Access Compliance Report
Public Rights-of-Way
(Pedestrian Signals)

Intersection ID: N/A	Main Street:	Cross Street: N/A	Location: N/A

ADA ID: 97FF72935852	Signal Type: Two Push Buttons-Non APS	Overall Compliance: No	Severity Score: BTN 1:N/A	BTN 2: N/A	No BTN: N/A

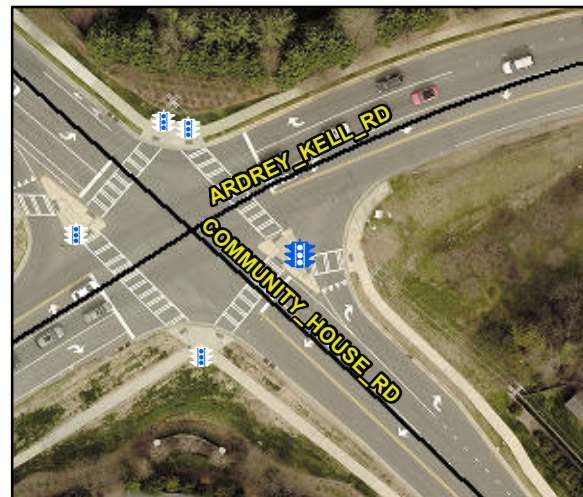
Surveyor Notes: N/A

Possible Solutions: Replace Signal Push Button With APS Button on New Post. Remove & Relocate Sign.
